# NORTHUMBERLAND DEVELOPMENT PROJECT **HOTEL**

**S73 APPLICATION**

THHTL-F3A-XX-XX-RP-A-0006

**DESIGN AND ACCESS STATEMENT ADDENDUM UPDATE**

**FIGURE 107.** Proposed Scheme Revision - Street Level Illustrative Landscape Plan

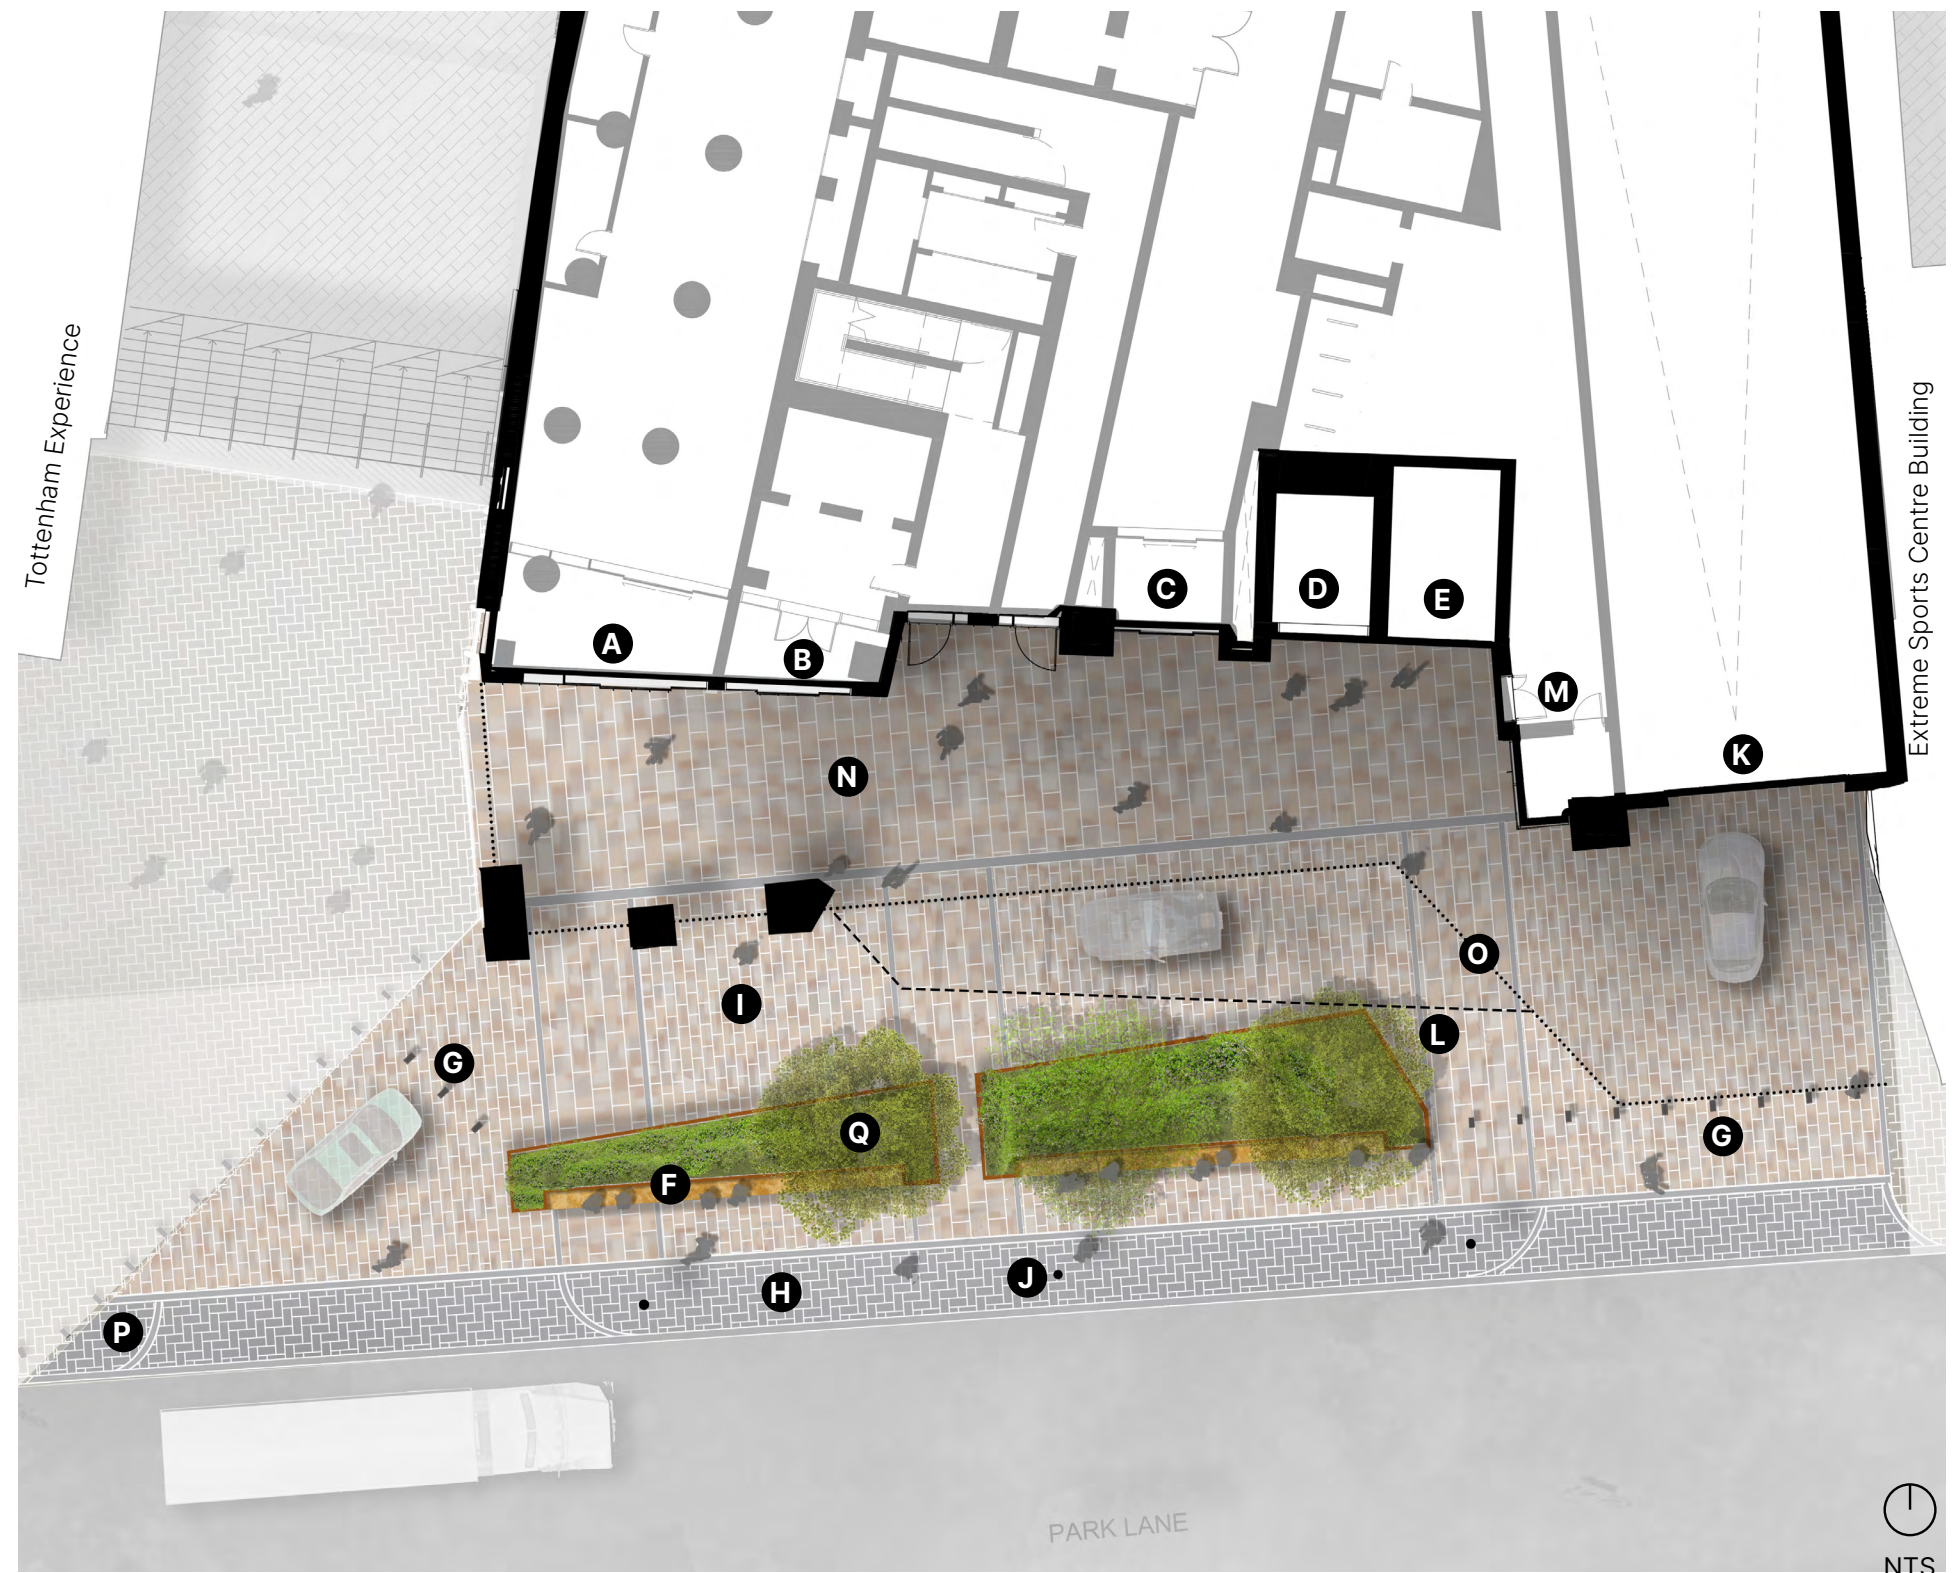
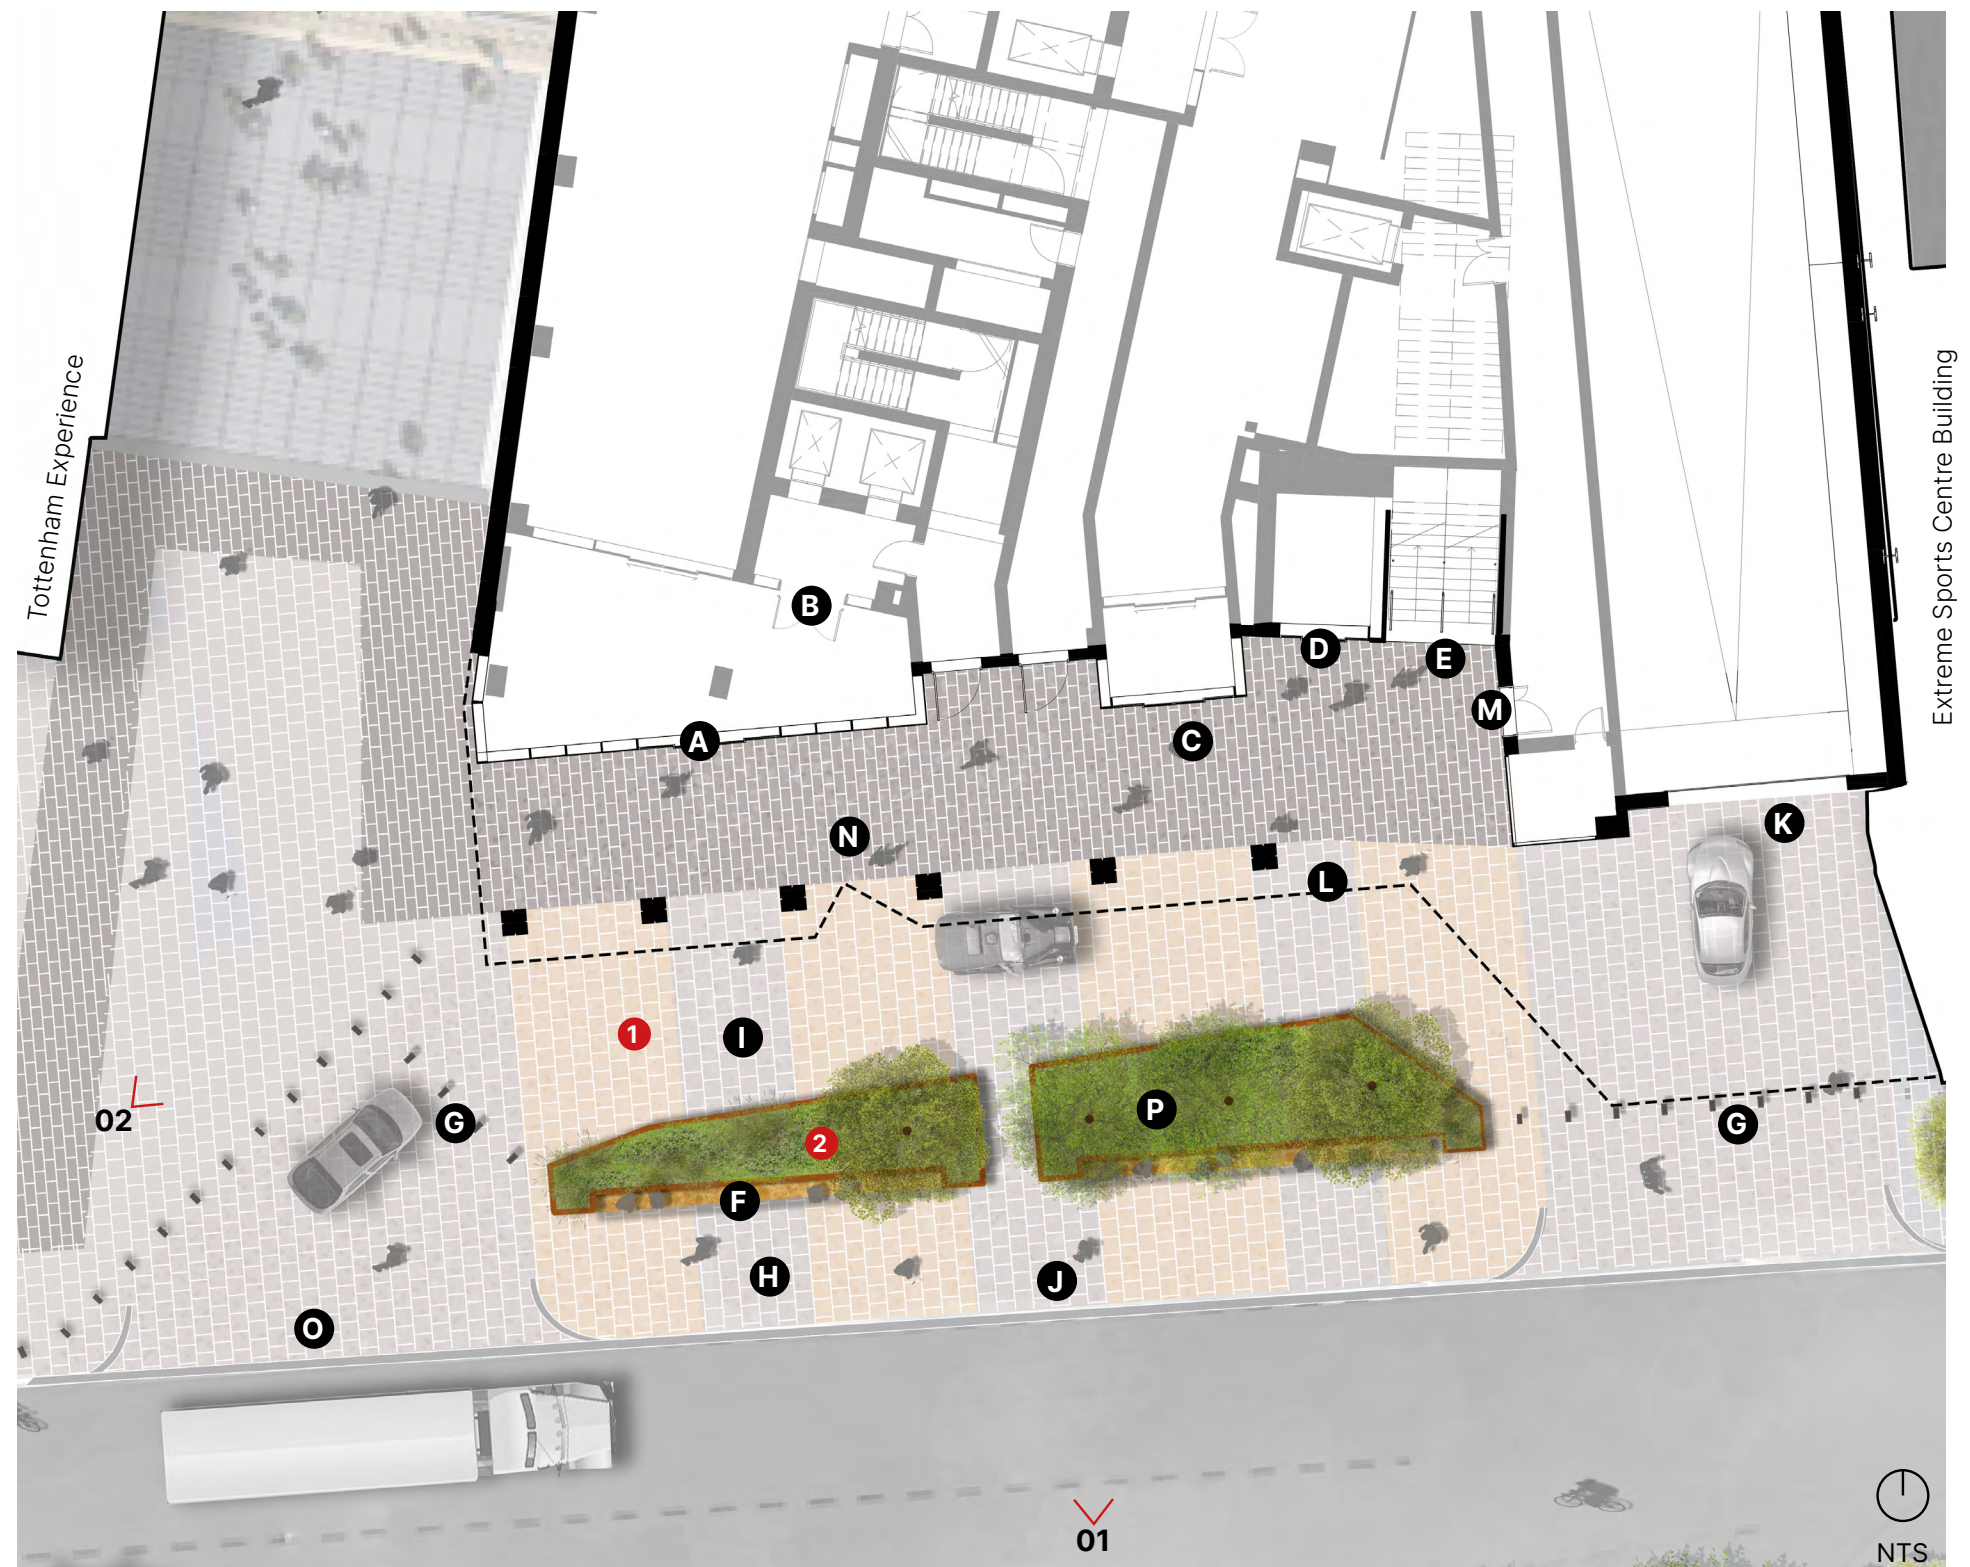
- Respond to new columns replacing previous fin design
  - Incorporate wider public realm paving design - striped elements from street to building frontage
- 2** Planter size and trees (canopy size reduced, numbers increased from 3 to 4) have been adjusted to work with updated tracking based on new columns

FIGURE 109. Proposed Scheme Revision - Podium Illustrative Landscape Plan

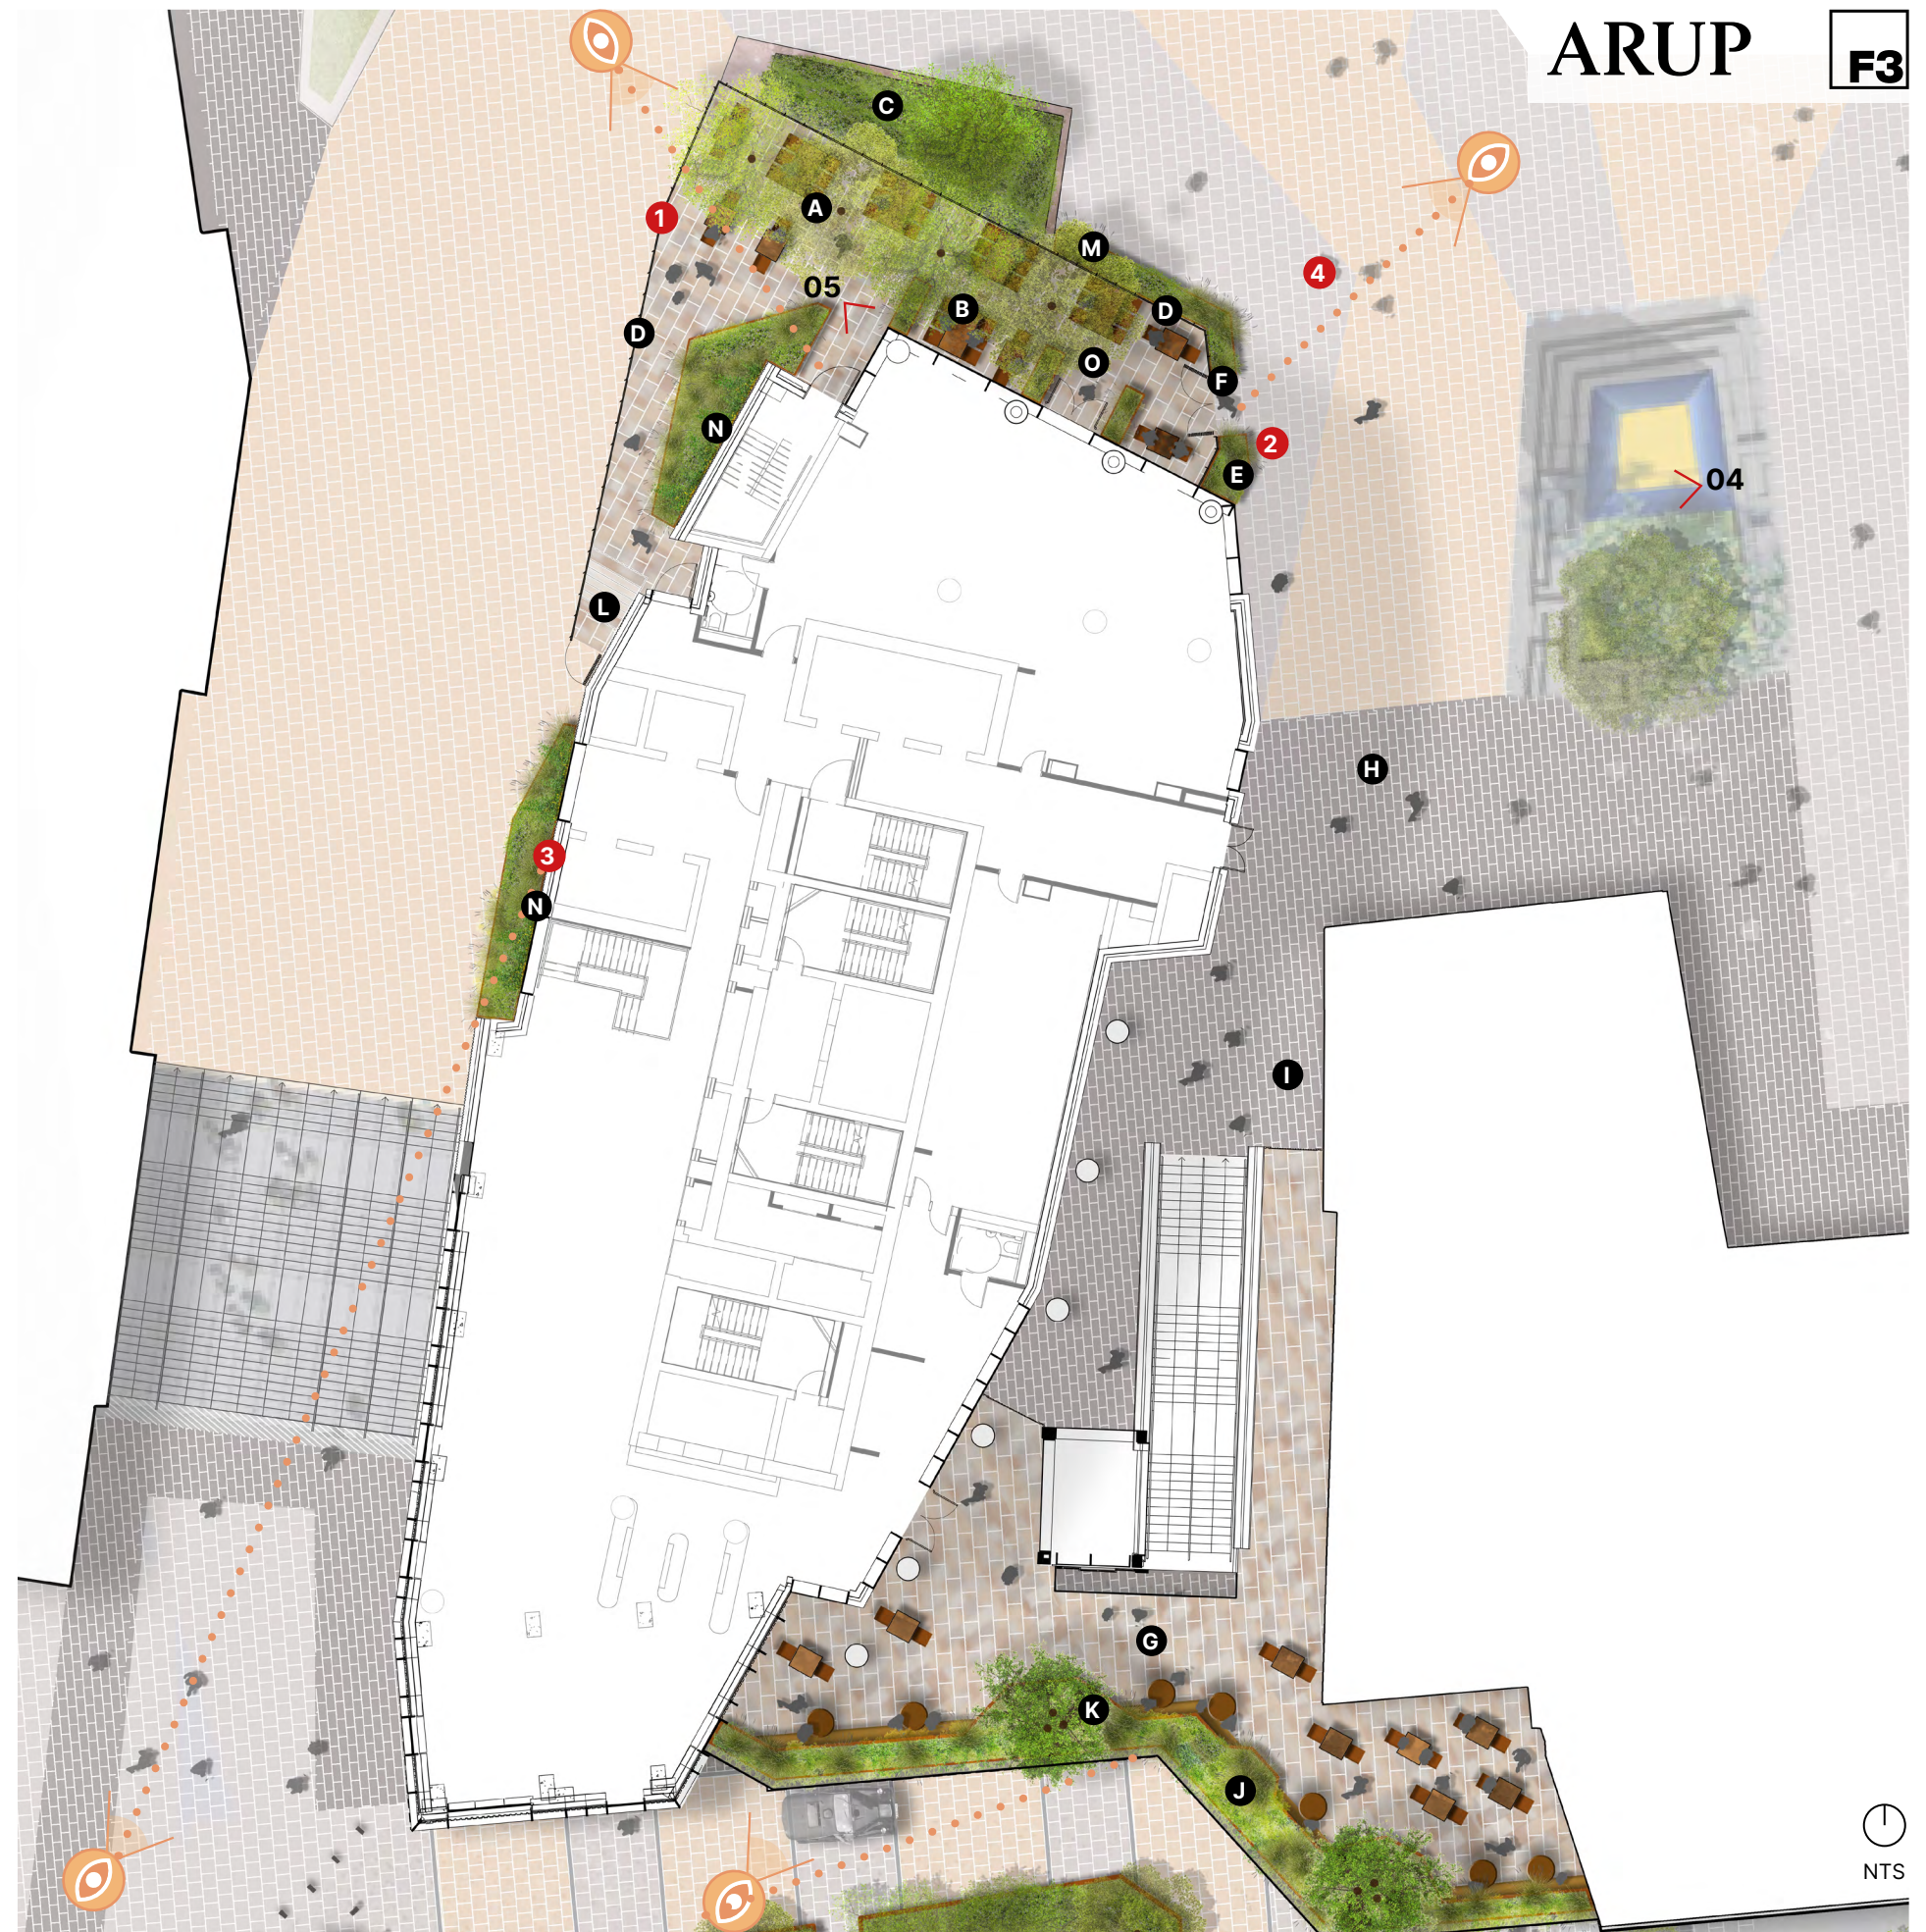
- 1 Enclosure to north terrace changed from vertical railings to glazed balustrade.
- 2 Planters added to east glazed balustrade.
- 3 Planter to west elevation enlarged and planted trellis incorporated into concrete panel facade elevation.
- 4 Paving design updated to reflect approved wider masterplan design.
